ALERT SERVICE BULLETIN

412-24-200

MODEL AFFECTED: 412EP

SUBJECT: ENGINE N1 CONTROL CABLE INSTALLATION, IMPROVEMENT OF.

Figure 3. Engine 1 N1 control cable, pre and post relocation.

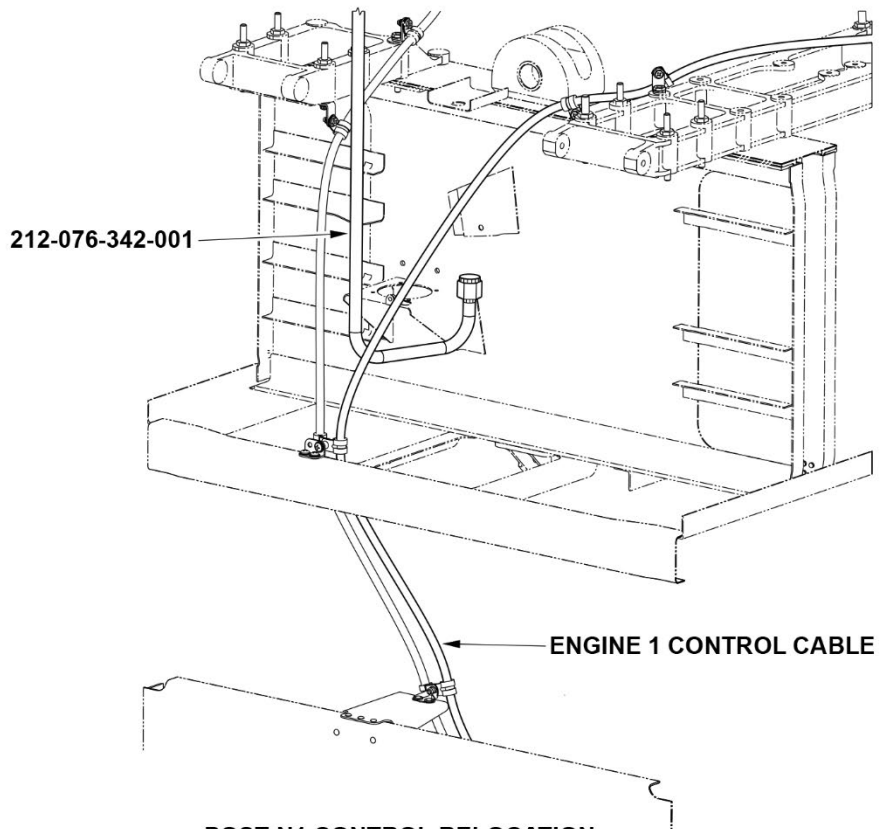
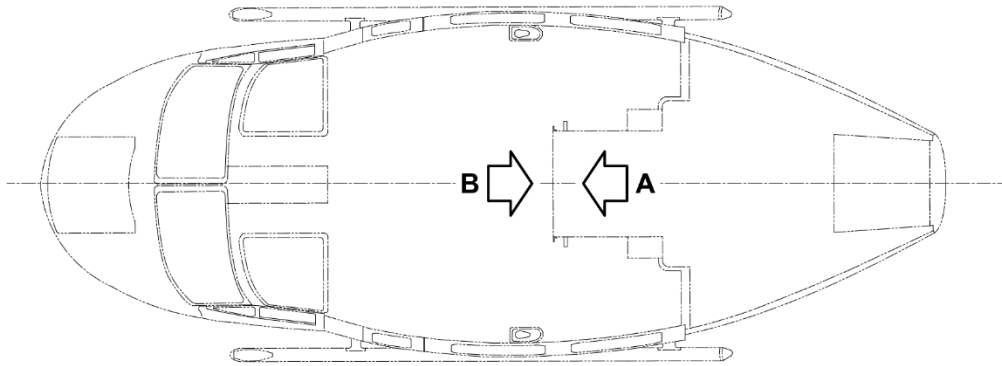
6. Use Figures 5 and 6 to correctly route and secure the N1 control cable installation in the center fuselage area. Detailed instructions are included in the Figures.
7. Install hydraulic tube assembly 212-076-342-001 after relocation of the engine 1 control cable as shown (Figure 3).
8. Once the N1 control cable installation is complete, verify that both throttles operate smoothly over the entire range of operation and that there is no fouling.
9. Install the previously removed center fuselage panels 212-030-276-001 and 412-030-237-101 (Figure 1).
10. Install the previously removed center floor panel 412-030-378-101 (Figure 2).
11. Make an entry in the helicopter logbook and historical service records indicating compliance with this Alert Service Bulletin.

Figure 4 (sheet 1 of 3). Bracket 412-060-715-113 installation.

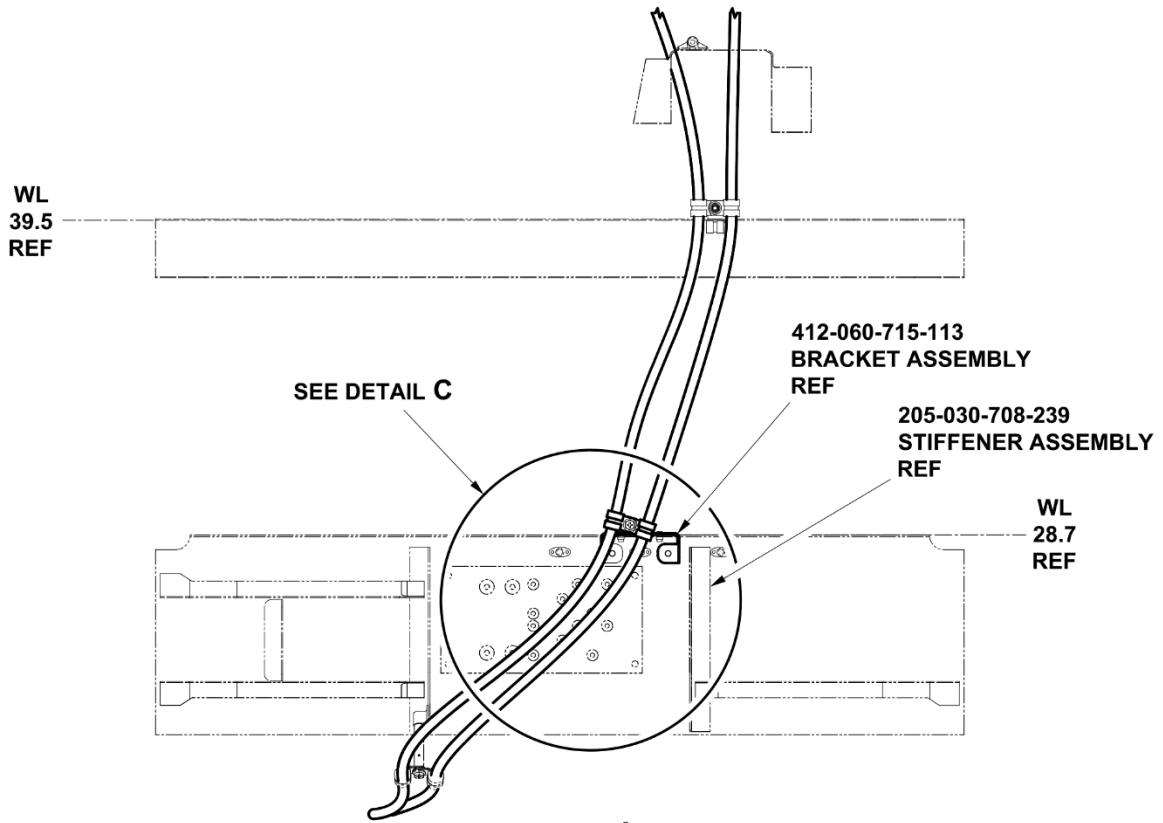
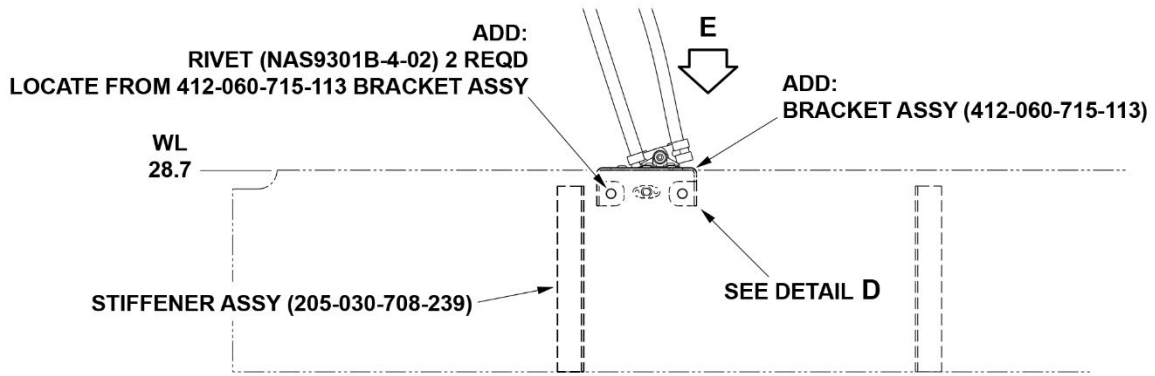
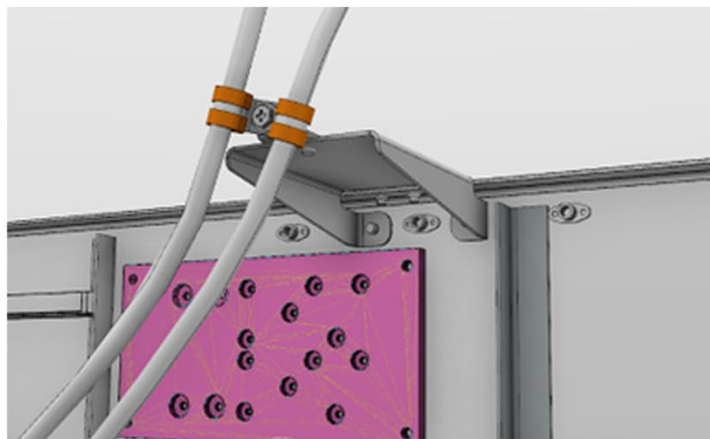
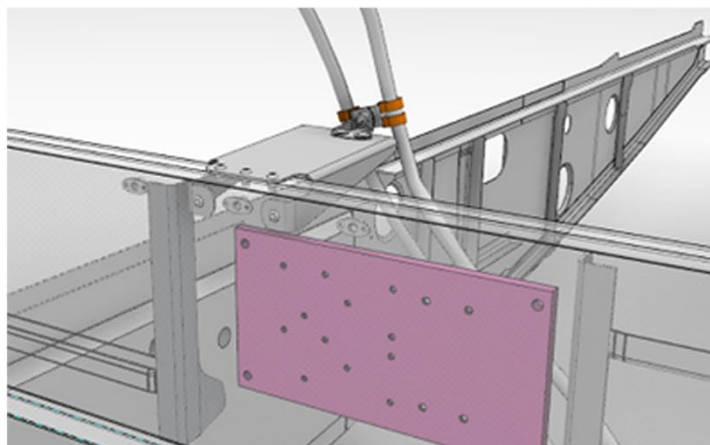
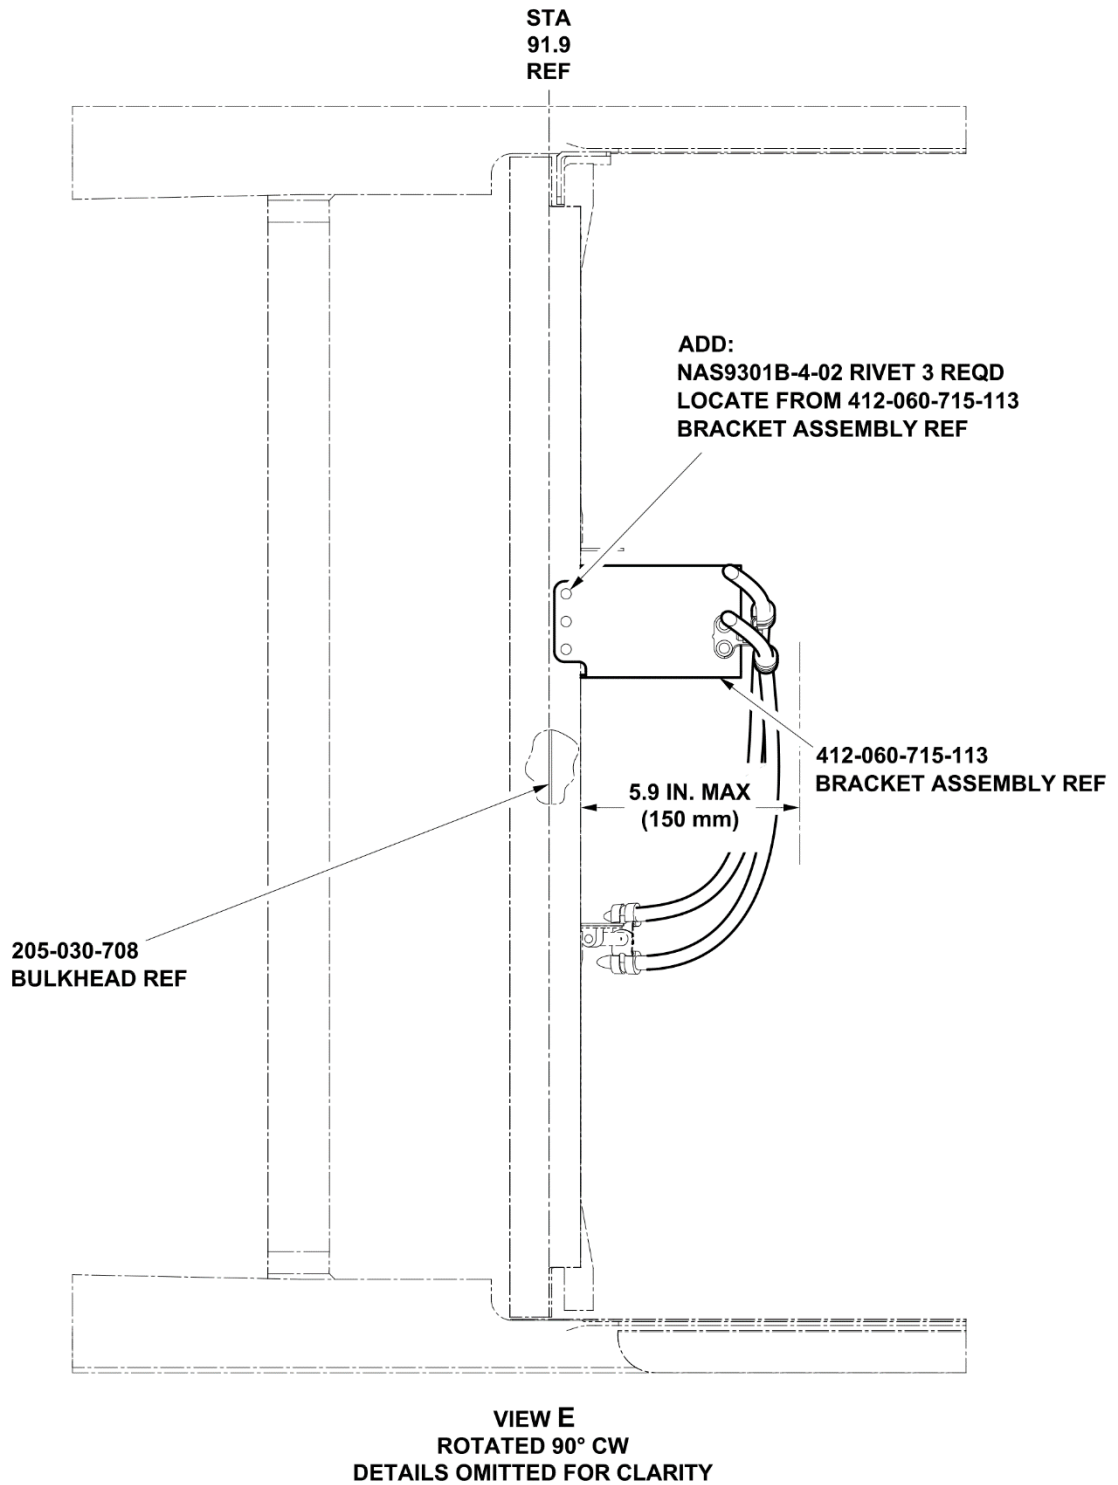
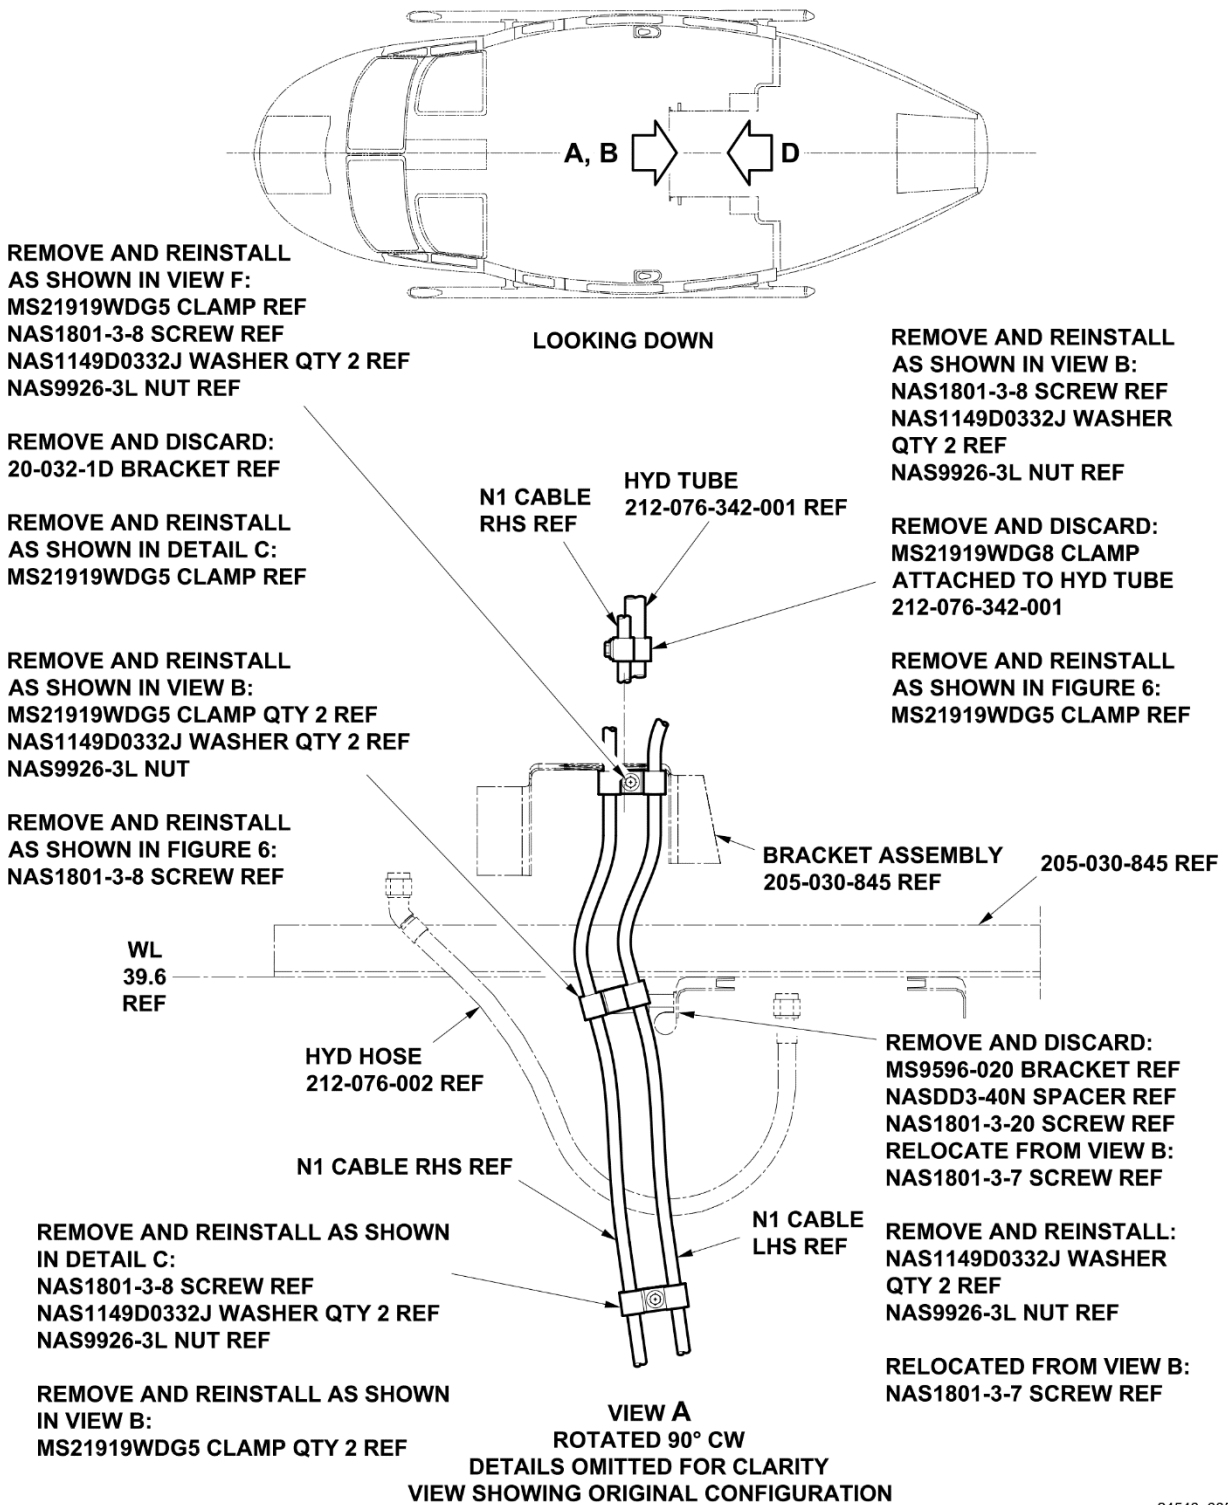
1. Prepare the helicopter for maintenance.
2. Gain access to the forward pylon area by removing panel assemblies 212-030-276-001 and 412-030-237-101 located in the center fuselage (Figure 1).
3. Gain access to the center floor area by removing panel assembly 412-030-378-101 (Figure 2).
4. Remove hydraulic tube assembly 212-076-342-001 for relocation of the engine 1 N1 control cable as shown (Figure 3).
5. Locate bracket assembly 412-060-715-113 as shown and install rivets with sealant (C-251) (Figure 4 and Figure 5 sheet 3).

Figure 5 (sheet 6 of 6). Post ASB configuration center fuselage.

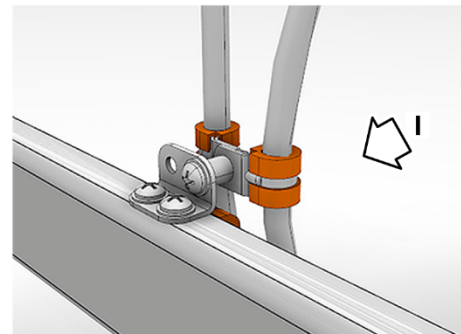
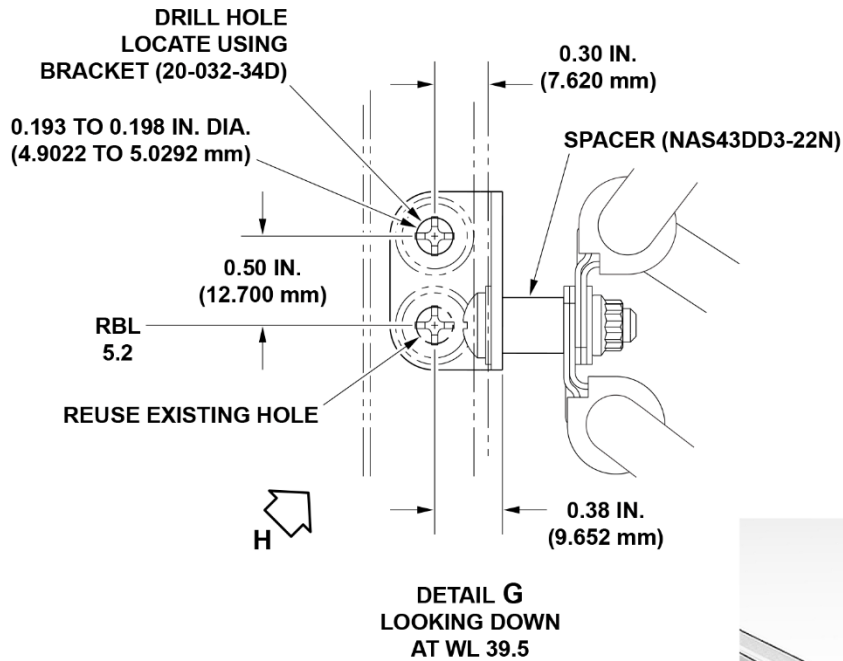
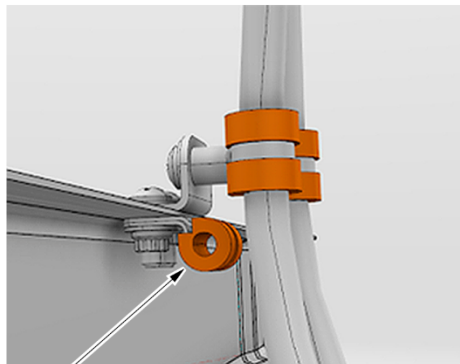
Maximum distance between N1 control cables and bulkhead must not exceed indicated value to ensure no fouling exists between the cargo suspension assembly when installed and pushed forward against the bumper assembly.

Figure 6. Post ASB configuration center floor.

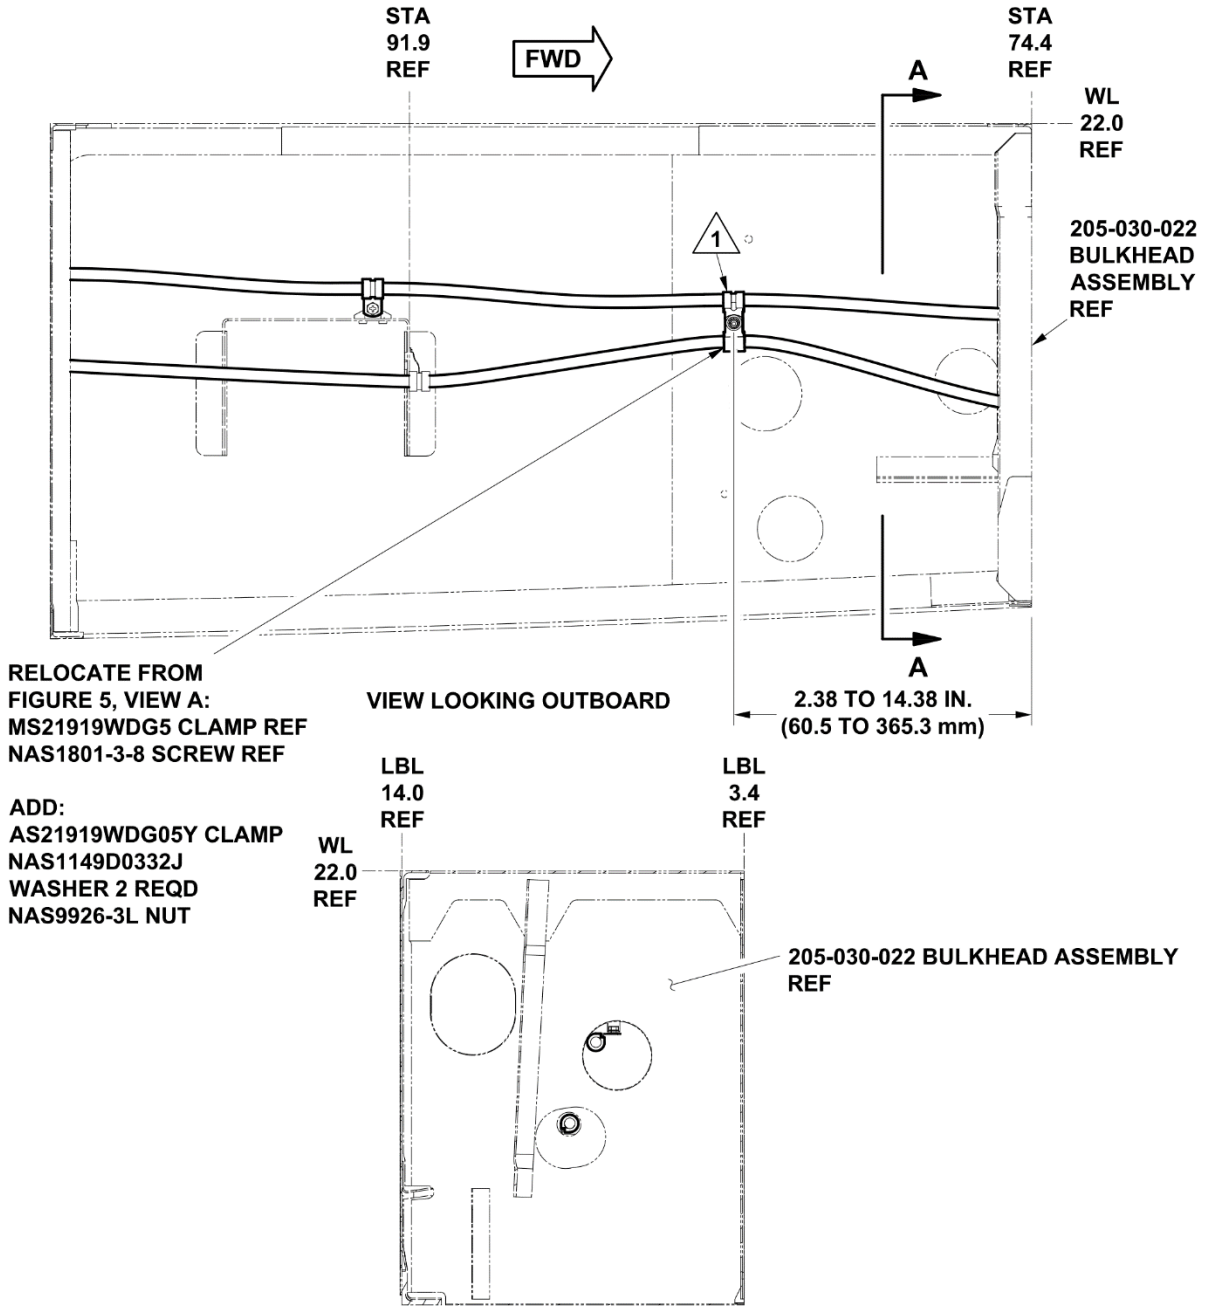
1 Locate clamping arrangement to avoid fouling between the N1 control cables and the 205-030-022 bulkhead assembly.
